**RFB NO. 313083 - ADDENDUM NO. 1**

**CONSTRUCTION OF EAST HIGHWAY GARAGE – SALT  
STORAGE FACILITY (BID PACKAGE A) AND  
MEDICAL EXAMINER OFFICE BUILDING (BID PACKAGE B)**

**DEPARTMENT OF PUBLIC WORKS,  
HIGHWAY & TRANSPORTATION  
3562 COUNTY HIGHWAY AB  
MCFARLAND, WISCONSIN**

### **Sheet A-208 – Salt Building Plans**

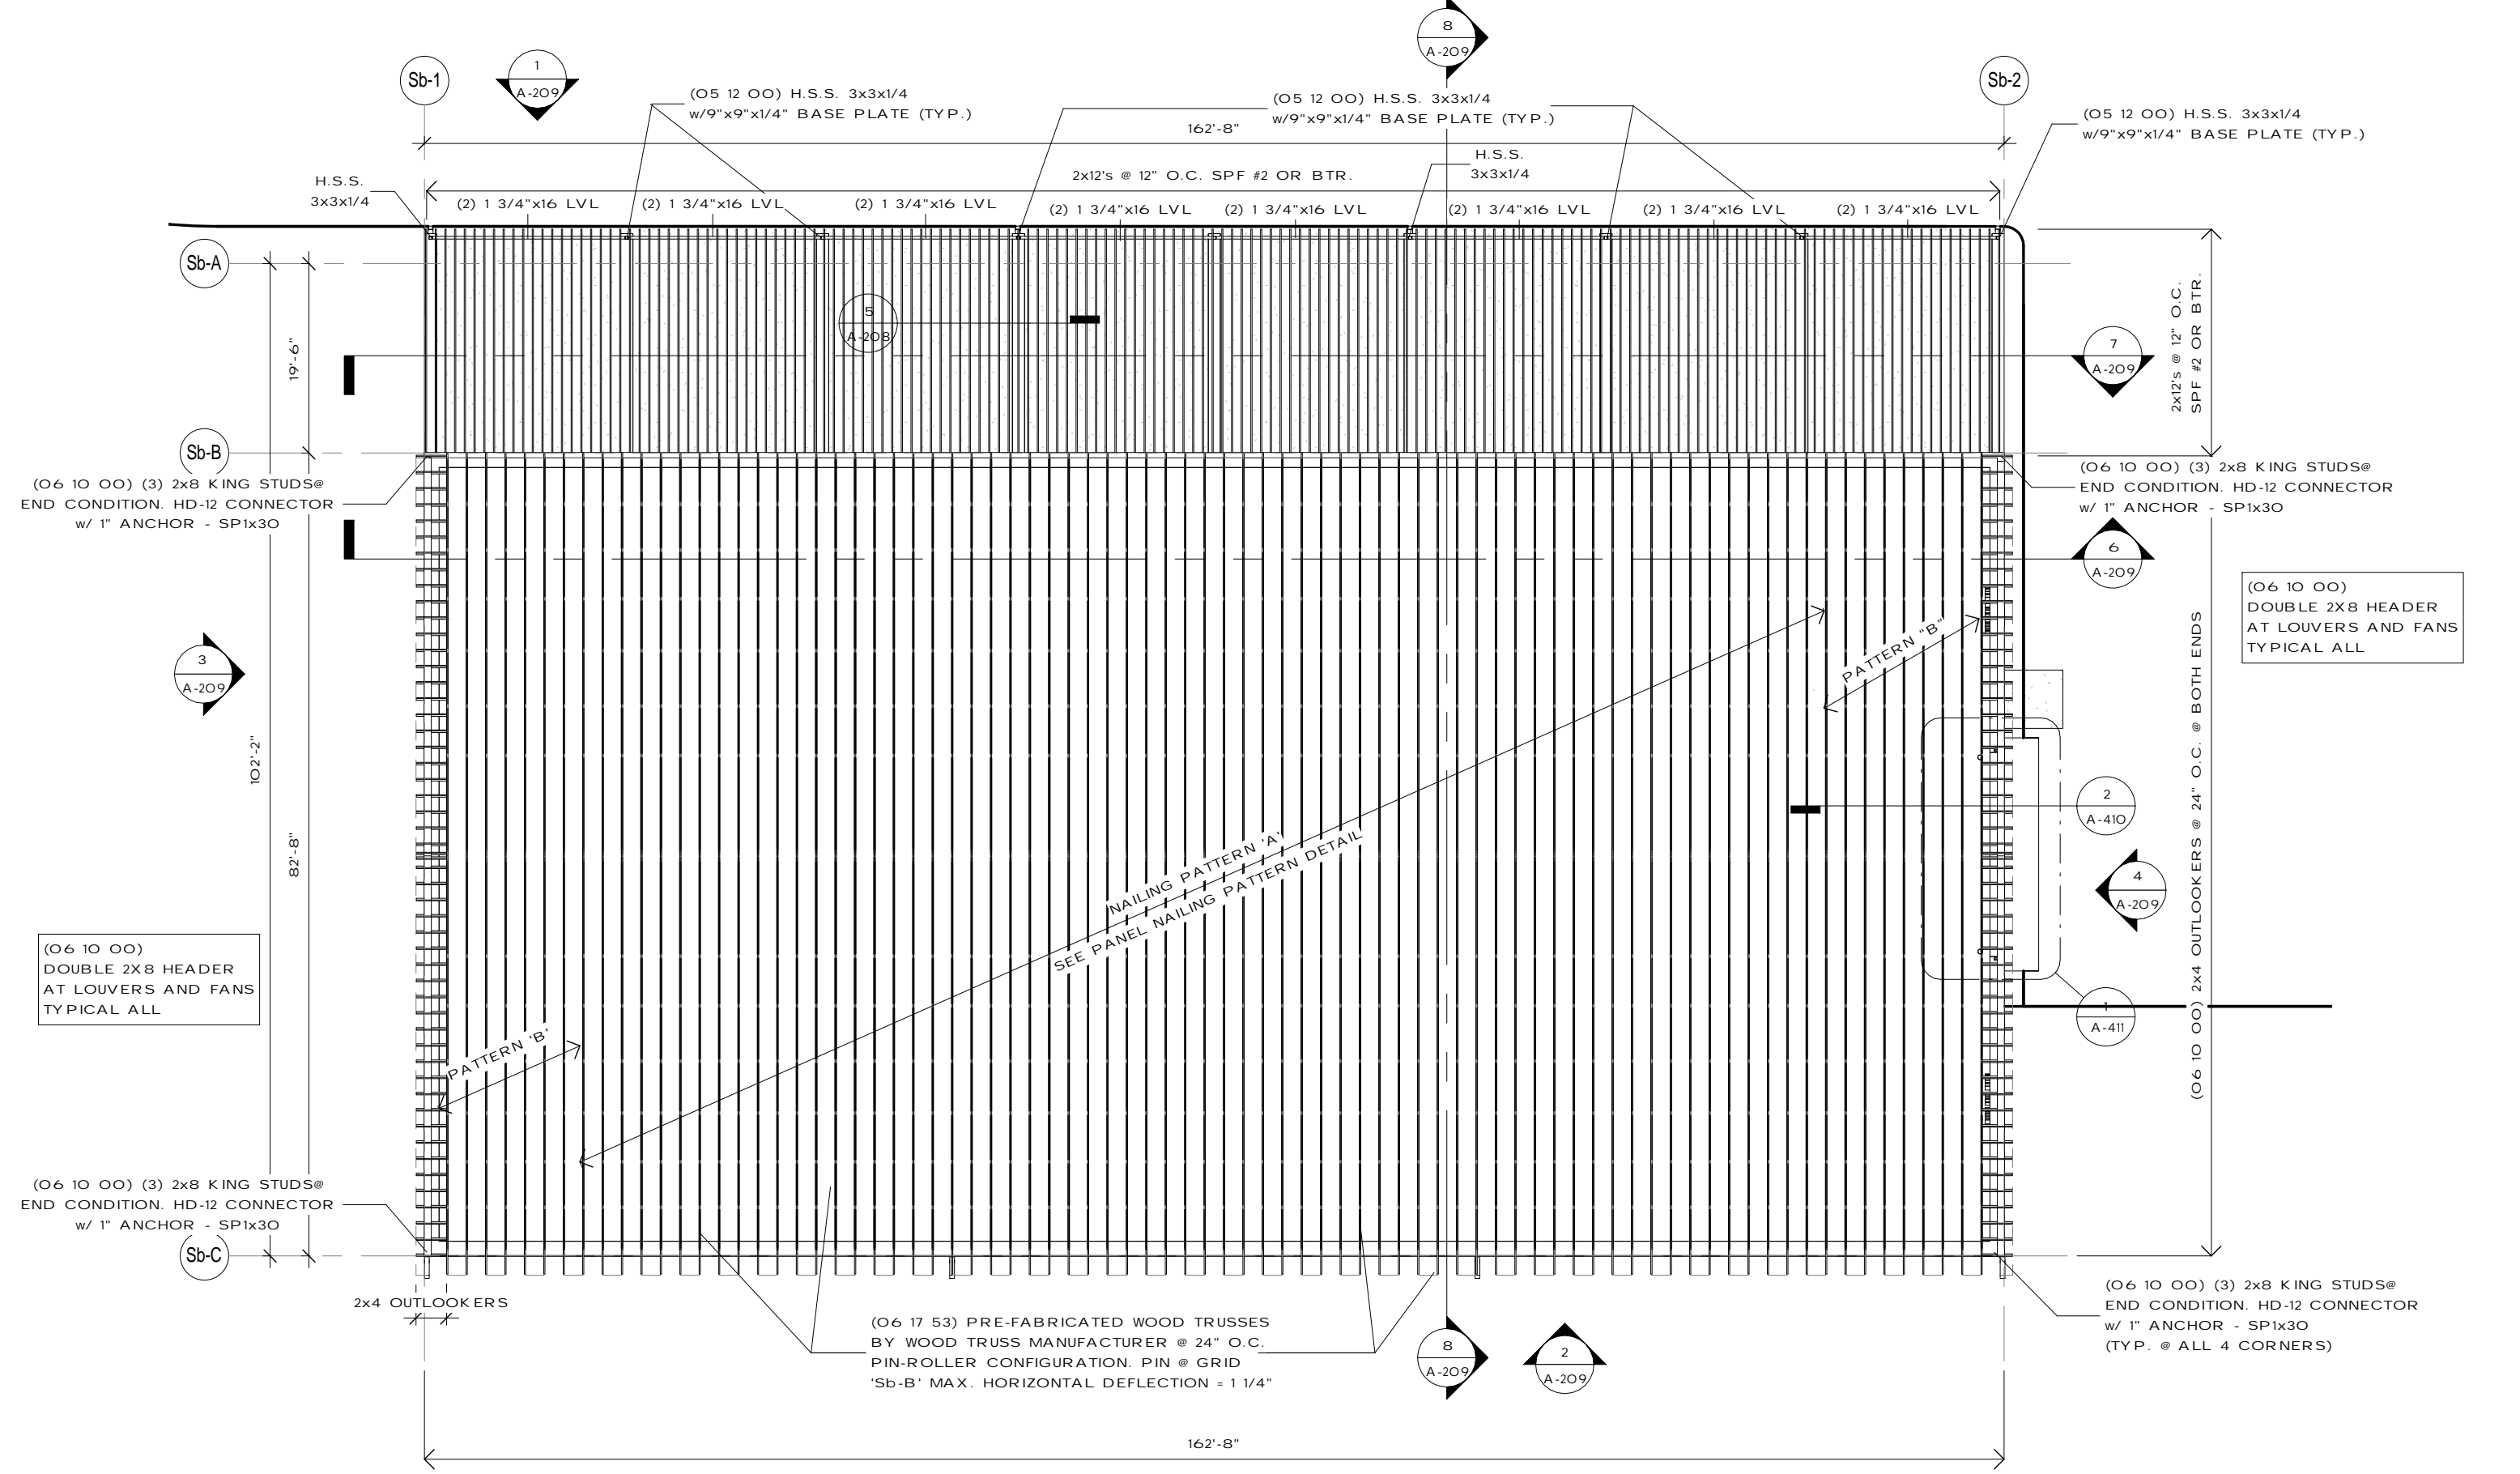
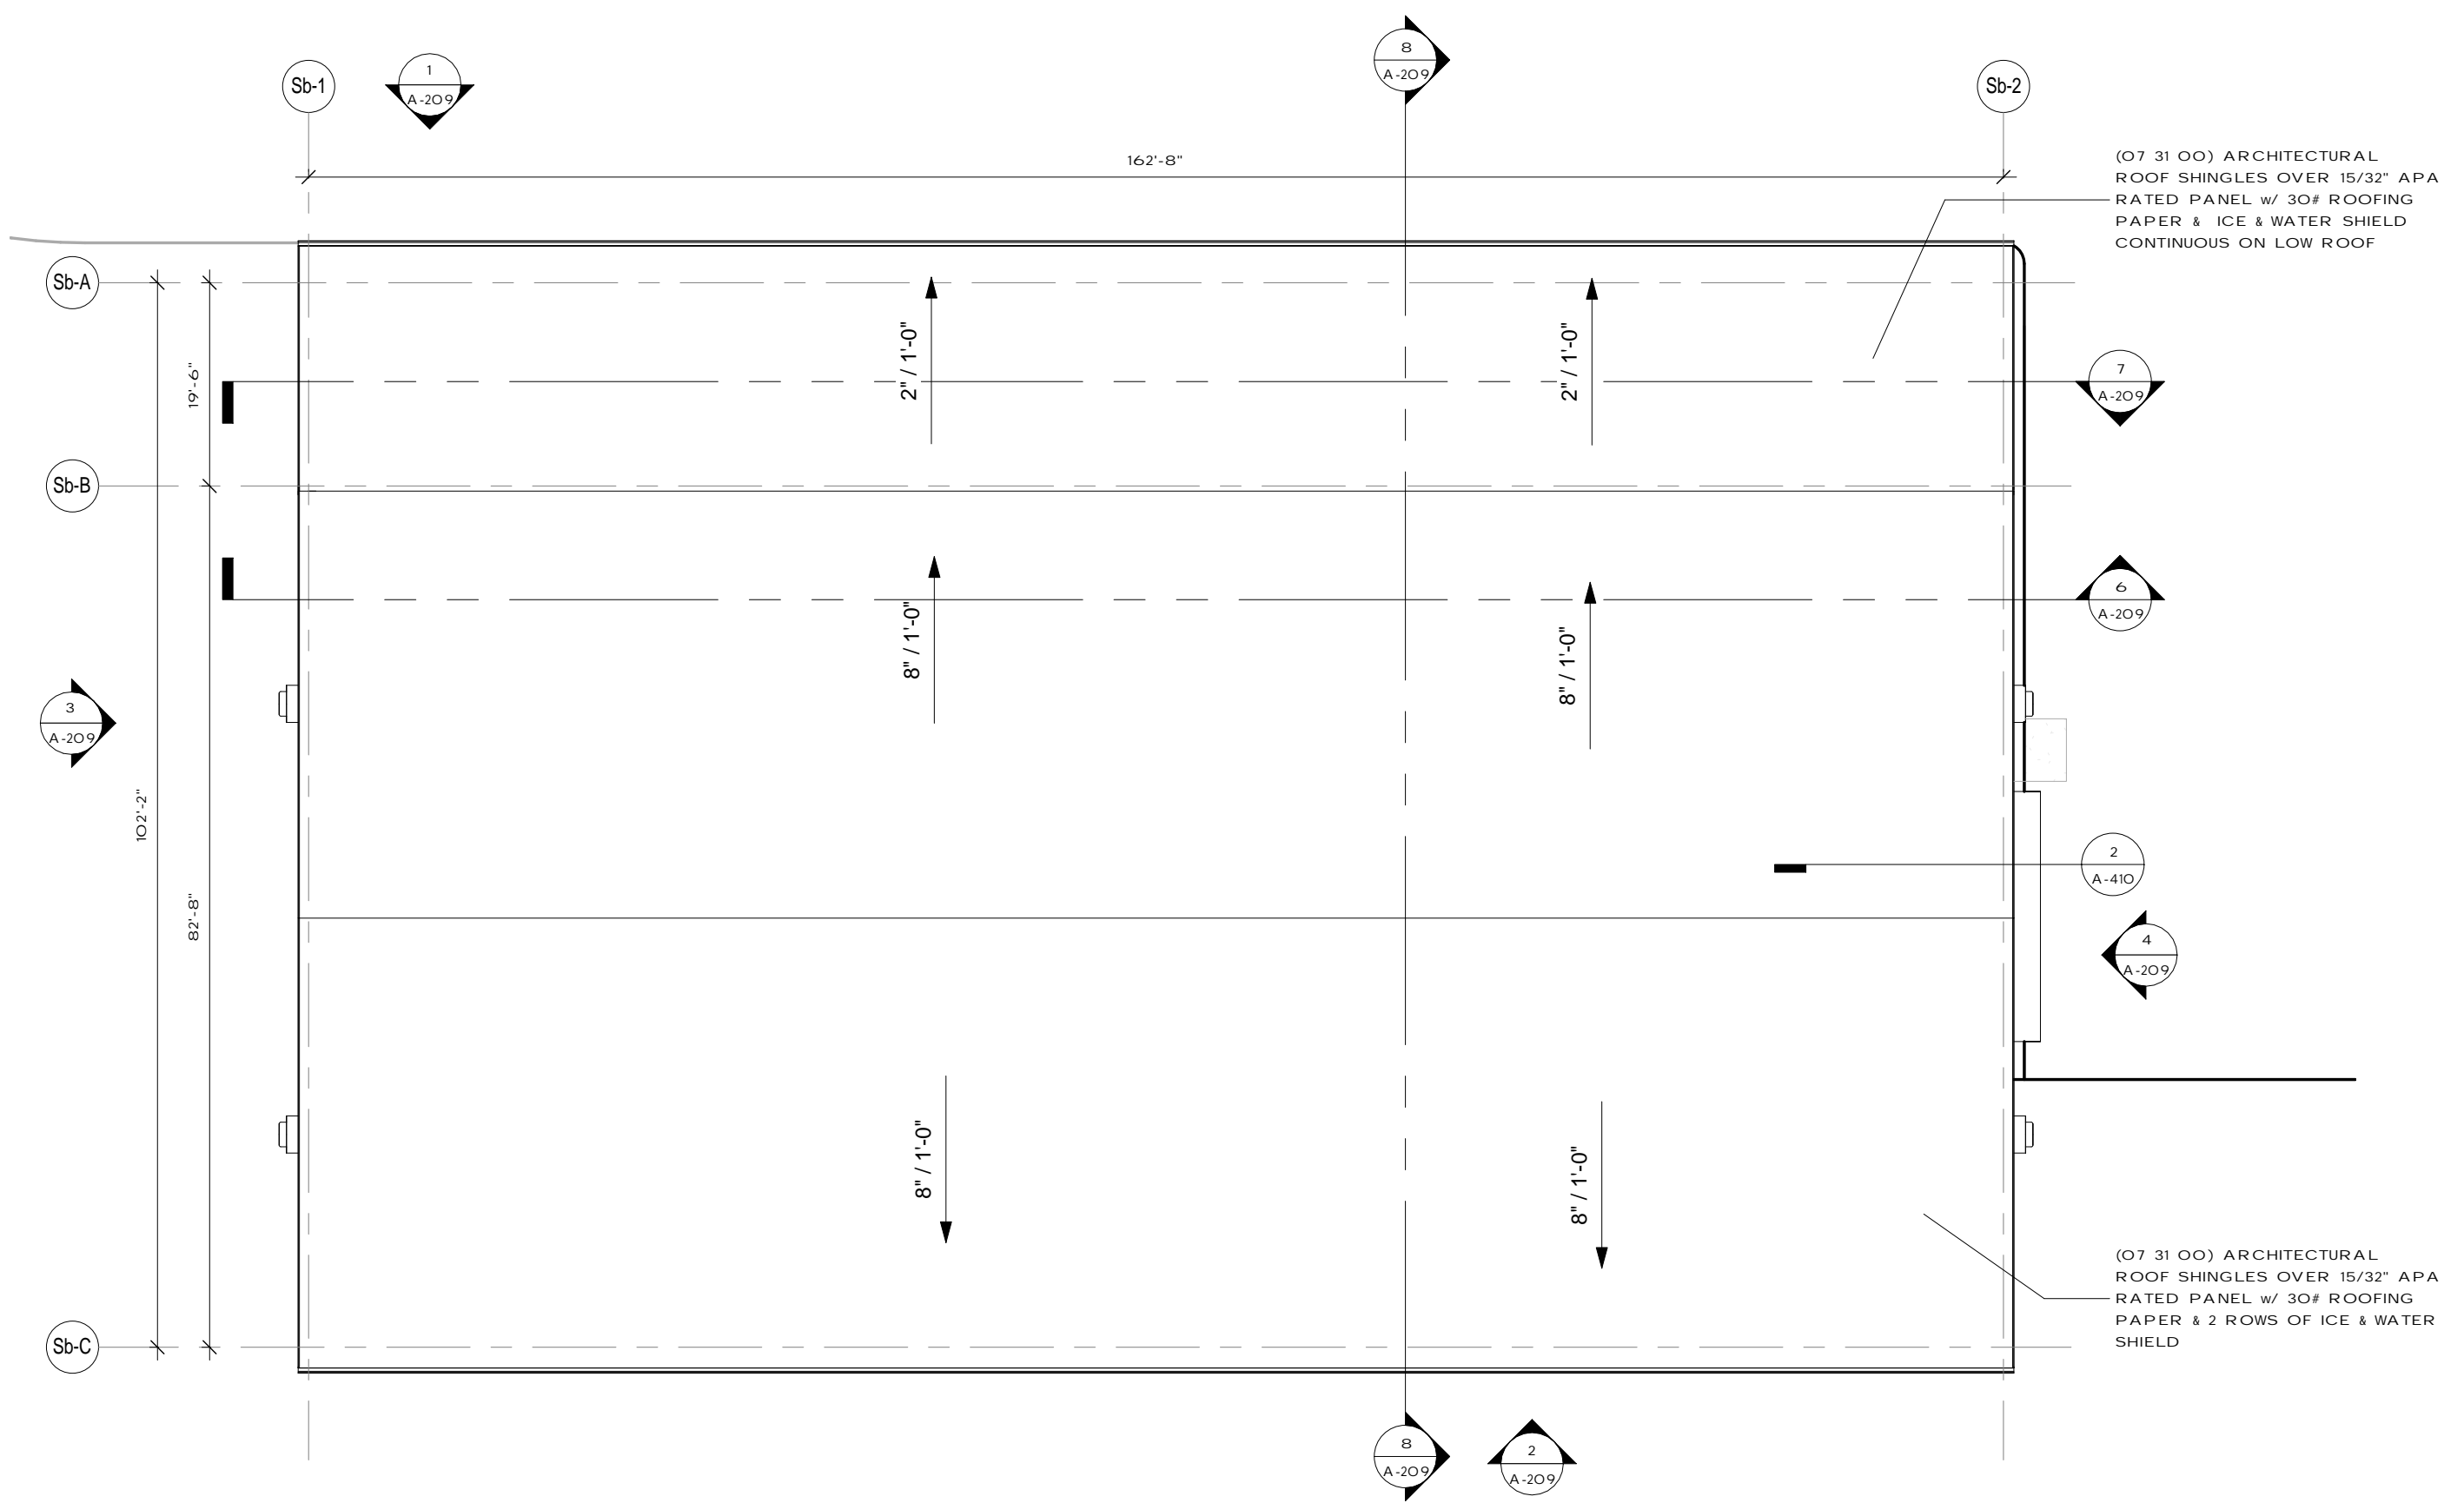
1. See revised sheet showing door tags.
